PUBLIC INTEREST REVIEW FOR GROUNDWATER APPLICATIONS

TO:		Water	· Rights Se	ection					Date	Ap	ril <u>10,</u>	2013		
FROM:	:	Grour	ndwater Se	ection	Marc No									
SUBJE	CT:	Appli	cation LL	1453			ewer's Name persedes		iew of			Date of Rev	view(s)	
OAR 69 welfare, to determ	90-310-1 safety ar mine whe	30 (1) 7 nd heali ether the	The Departi th as descri presumpti	<i>bed in ORS</i> on is establi	resume that 537.525. Do shed. OAR	<i>a propos</i> epartment 690-310-	ed ground staff revi 140 allow	iew g s the	er use will e groundwater e proposed u ngency polic	applicates a see be	ions u dified	nder OAF or condi	8 690-310 tioned to	0-140 meet

Application LL-1453

Date: April 10, 2013

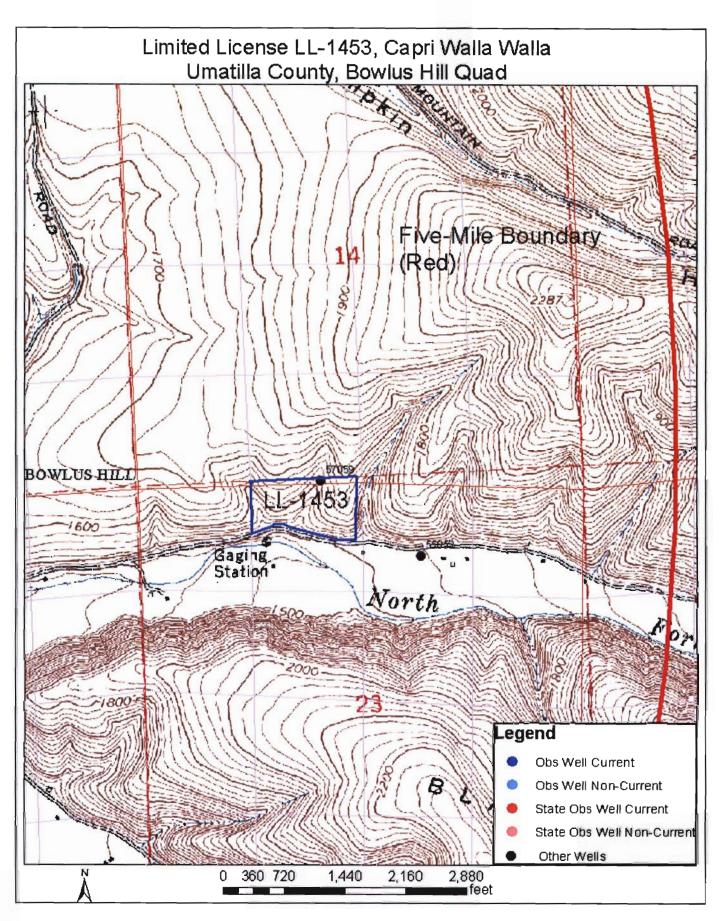
The	ere is concern about the well construction. The well log, UMAT 57059, indicates that there is "broken rock" from
		to 210 feet below land surface. The well constructor, Goral LaPorte, indicated that this was a fractured area but re was no water. Goral LaPorte also indicated that a nearby well, UMAT 4042, encountered the same
	hyd	Irogeological conditions. UMAT 4042 indicates a black cinder and lava rock – very porous with a small amount of
		ter (3 – 5 gpm). The static water level reported on UMAT 4042 was 145' on 12/29/1980. The static water level in IAT 57059 was 175' on 7/15/1980. The two wells are located about 90 feet apart and at similar elevations, not
	eno	ough to account for the 30 foot difference in water levels. Additional information needs to be collected to determine
		here is borehole flow prior to issuing a permit. See attached cross section. Allow irrigation through November 31, 3, then have the pump(s) pulled and do a video and temperature log for each well.

b.	Condition to allow groundwater production from no shallower than ft. below land surface;
	c.	Condition to allow groundwater production only from a single aquifer in the Columbia River Basalt groundwater reservoir between approximately 270 ft. and 300 ft. below land surface;

d.	Condition to allow production only from a single aquifer in the Columbia River Basalt groundwater reservoir;
	e.	Well reconstruction is necessary to accomplish one or more of the above conditions. The problems that are likely to occur with this use and without reconstructing are cited below. Without reconstruction, I recommend withholding issuance of the permit until evidence of well reconstruction is filed with the Department and approved by the Groundwater Section.
		Describe injury —as related to water availability— that is likely to occur without well reconstruction (interference w/ senior water rights, not within the capacity of the resource, etc):
В3.	Fre gro the	oundwater availability remarks: The well is located within the five-mile boundary around the City of Milton-ewater wells. Based on the information on the Water Well Report and the location of the well, a barrier to undwater separates the proposed well from the City's wells and a limited license could be issued. If, in the future, well is deepened, that determination might change. Therefore, condition B2 (c) limits the well to the aquifer that is rently developed.
